SERVICE BULLETIN

_{N°} 139-657

DATE: February 28, 2024

ATA 56 - CABIN STORM WINDOW LH-RH INSTALLATION

3G5630A03311 CABIN STORM FWD WINDOW LH INSTALLATION

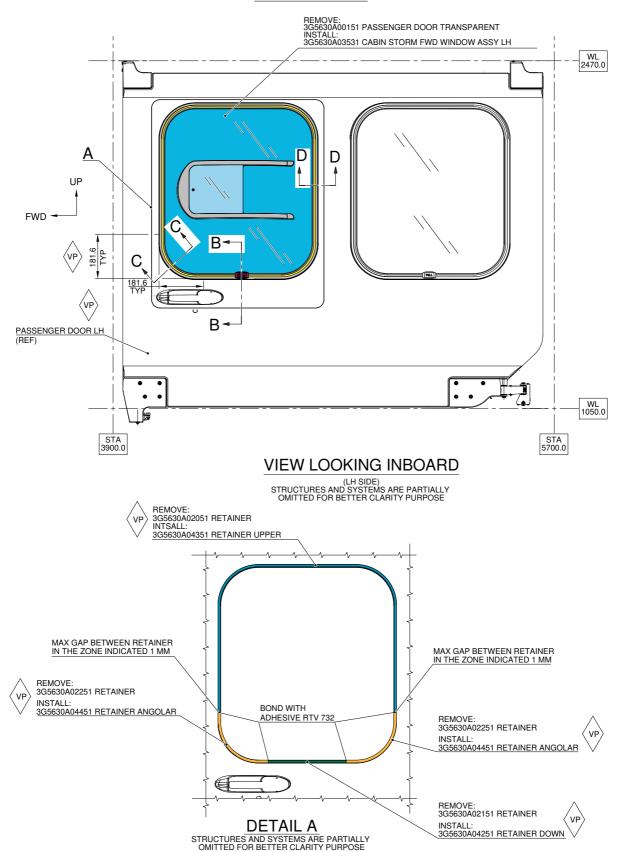
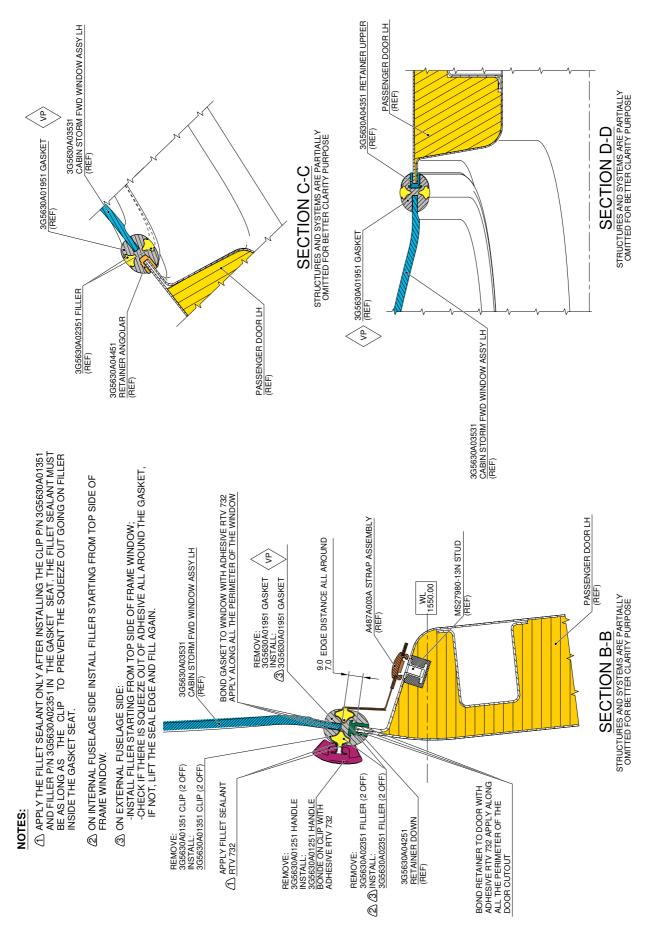
- After 30 minutes, remove squeeze out adhesive on internal and external side.
- 4. In accordance with the applicable steps of AMP DM 39-A-56-35-01-00A-920A-A and with reference to Figures 1 and 2, install the following components on the passenger door LH:

- the cabin storm FWD window assy LH P/N 3G5630A03531;
 - the retainer down P/N 3G5630A04251;
 - the retainer upper P/N 3G5630A04351;
 - n°2 retainers angolar P/N 3G5630A04451;

- the gasket P/N 3G5630A01951;
 - n°2 fillers P/N 3G5630A02351;
 - the handle P/N 3G5630A01251;
 - the clip P/N 3G5630A01351;
 - the strap assy P/N A487A003A.

3G5630A03411 CABIN STORM FWD WINDOW RH INSTALLATION

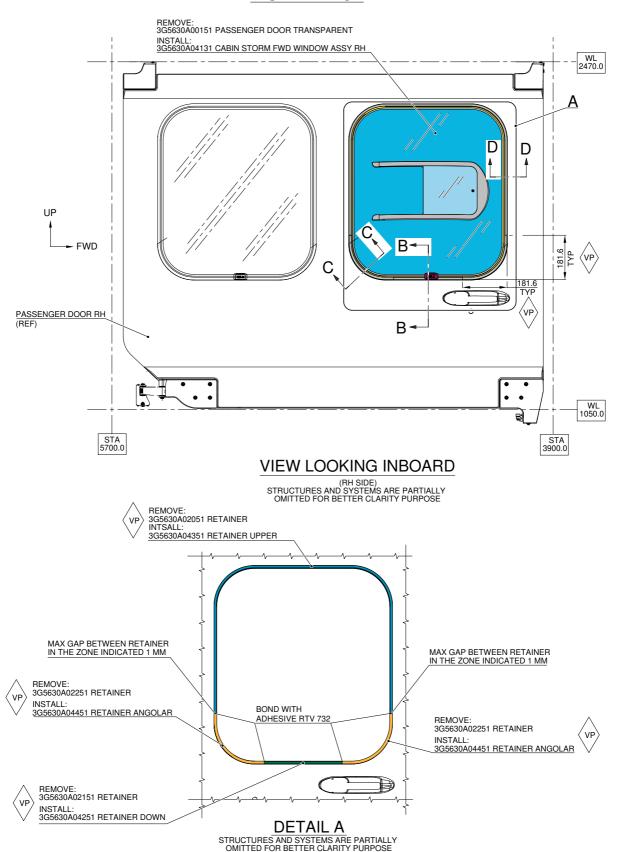
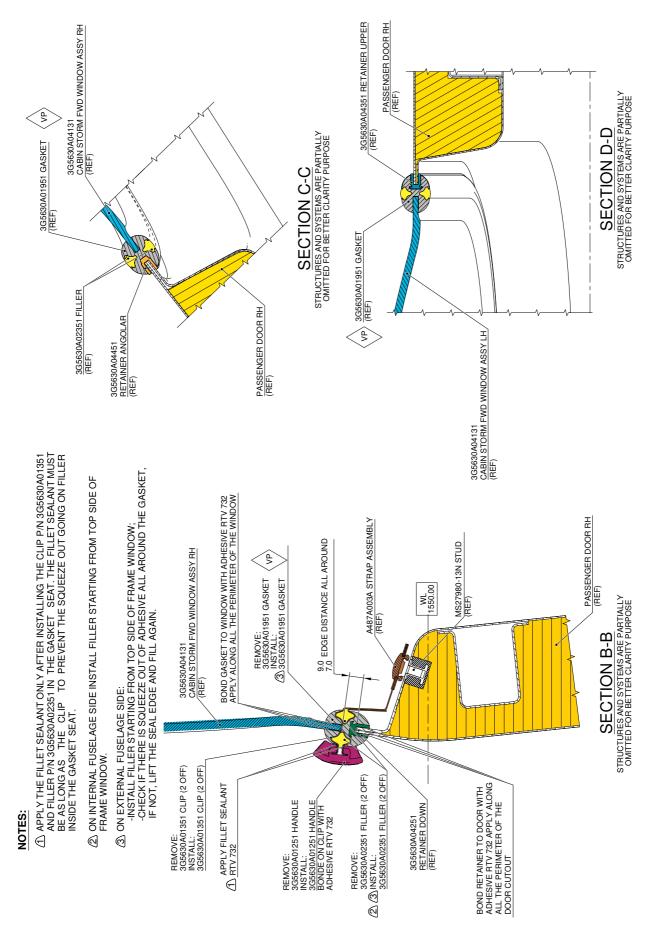
- Sanding of the gasket, filler and retainer (rubber parts) is not permitted.
- During the installation phase, it is not allowed to stretch the gasket, the filler and the retainer.
- To ensure a correct bonding / adhesion between the transparent and the gasket and between the retainer and the door panel, make sure that during the adhesive application phase there is a squeezeout of the adhesive itself. The bonding process must be performed using a tool or gun or syringe.
- After 30 minutes, remove squeeze out adhesive on internal and external side.
- 4. In accordance with the applicable steps of AMP DM 39-A-56-35-02-00A-920A-A and with reference to Figures 3 and 4, install the following components on the passenger door RH:
 - the cabin storm FWD window assy RH P/N 3G5630A04131;

- the retainer down P/N 3G5630A04251;
- the retainer upper P/N 3G5630A04351;
- n°2 retainers angolar P/N 3G5630A04451;
- the gasket P/N 3G5630A01951;
- n°2 fillers P/N 3G5630A02351;

- the handle P/N 3G5630A01251;
- the clip P/N 3G5630A01351;
- the strap assy P/N A487A003A (if necessary).
- In accordance with the applicable steps of AMP DM 39-A-11-00-01-00A-720A-A and with reference to Figure 5 Section A-A, install n°2 decals P/N A180A016E22 on the inner side of the cabin storm FWD window assy RH P/N 3G5630A04131.

Figure 5

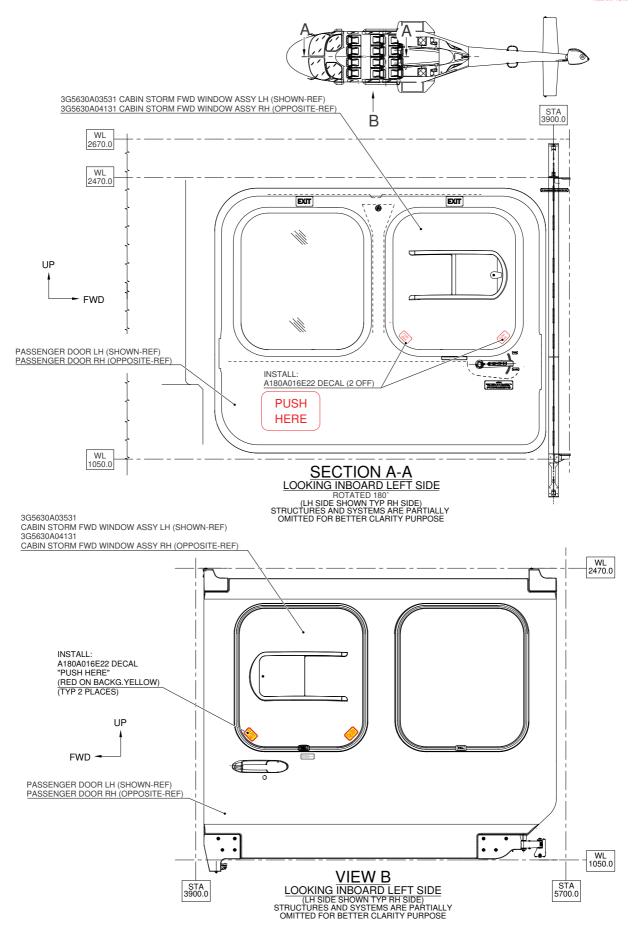
- In accordance with the applicable steps of AMP DM 39-A-11-00-01-00A-720A-A and with reference to Figure 5 Section A-A, install n°2 decals P/N A180A016E22 on the inner side of the cabin storm FWD window assy LH P/N 3G5630A03531.

- 6. In accordance with the applicable steps of AMP DM 39-A-11-00-01-00A-720A-A and with reference to Figure 5 View B, install n°2 decals P/N A180A016E22 on the outer side of the cabin storm FWD window assy LH P/N 3G5630A03531.

Figure 6

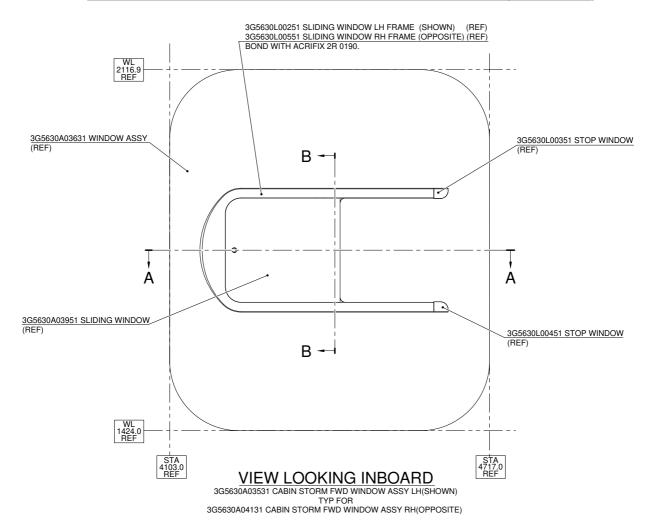
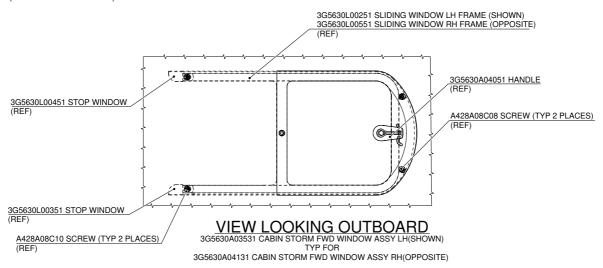
- 3. With reference to Figures 6 thru 8, rework the cabin storm FWD window assy LH P/N 3G5630A03531 as described in the following procedure:
 - 3.1 In accordance with the applicable steps of AMP DM 39-A-56-35-00-00A-92AA-A and with reference to Figures 6 and 7, remove the sliding window LH frame P/N 3G5630L00251 from the cabin storm FWD window assy LH.

3.7 In accordance with the applicable steps of AMP DM 39-A-56-35-00-00A-92AA-A and with reference to Figures 6 and 7, reinstall the sliding window LH frame P/N 3G5630L00251 and the other components previously removed (Ref. step 3.1), on the cabin storm FWD window assy LH.

Figure 7

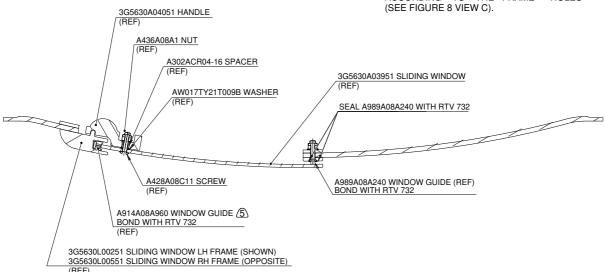
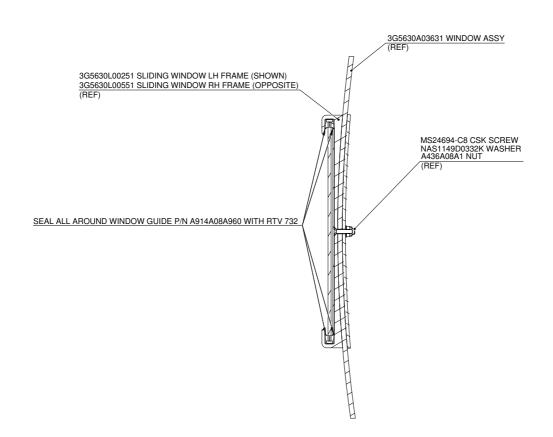
- 3.4 With reference to Figure 7 Section A-A, install the new window guide P/N A914A08A960 by means of adhesive RTV 732 (C126) on the reworked sliding window LH frame.
- 3.5 With reference to Figure 7 Section B-B, seal all around the window guide P/N A914A08A960 by means of adhesive RTV 732 (C126).

If necessary, it is possible to add thickness to the window guide P/N A989A08A240 using adhesive RTV 732 (C126) until the guide is against the sliding window P/N 3G5630A03951 (Ref. Figure 7 Section A-A).

3.6 With reference to Figure 7 Section A-A, seal all around the window guide P/N A989A08A240 by means of adhesive RTV 732 (C126).

⑤ CUT THE WINDOW GUIDE P/N A914A08A960 ACCORDING TO THE FRAME HOLES (SEE FIGURE 8 VIEW C).

Figure 8

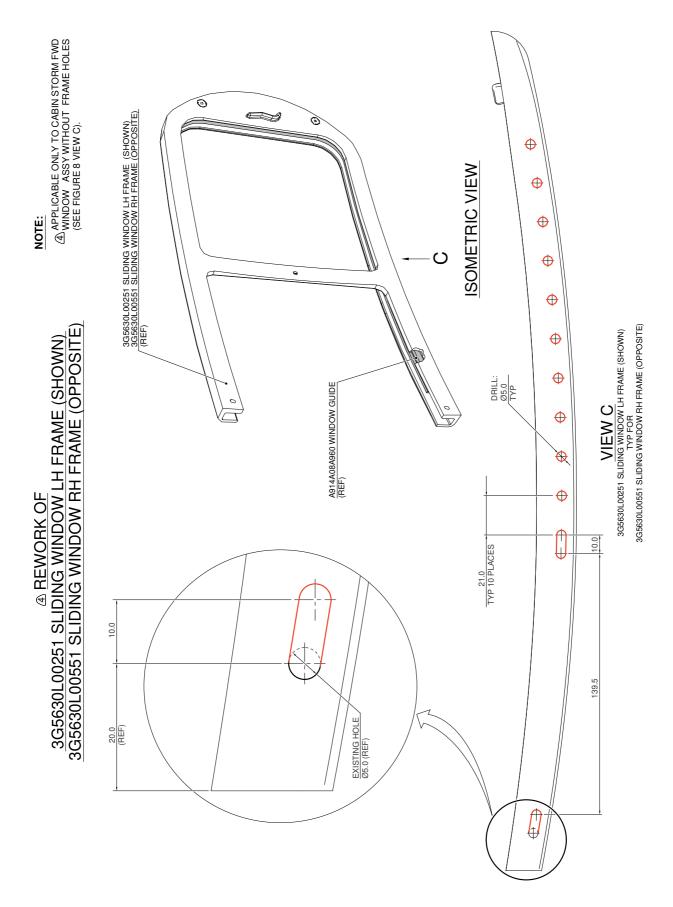
The following step 3 is applicable only to cabin storm FWD window assy LH P/N 3G5630A03531 without frame holes (Ref. Figure 8 View C).

- 3.2 With reference to Figure 8 View C, rework the sliding window LH frame P/N 3G5630L00251 as shown in figure.
- 3.3 With reference to Figure 8 "Isometric view", if the window guide P/N A914A08A960 has been damaged during the sliding window LH frame rework, remove the damaged window guide and proceed with the following step 3.4, otherwise skip to step 3.5.

Cut the new window guide P/N A914A08A960 according to the frame holes (Ref. Figure 8 View C).
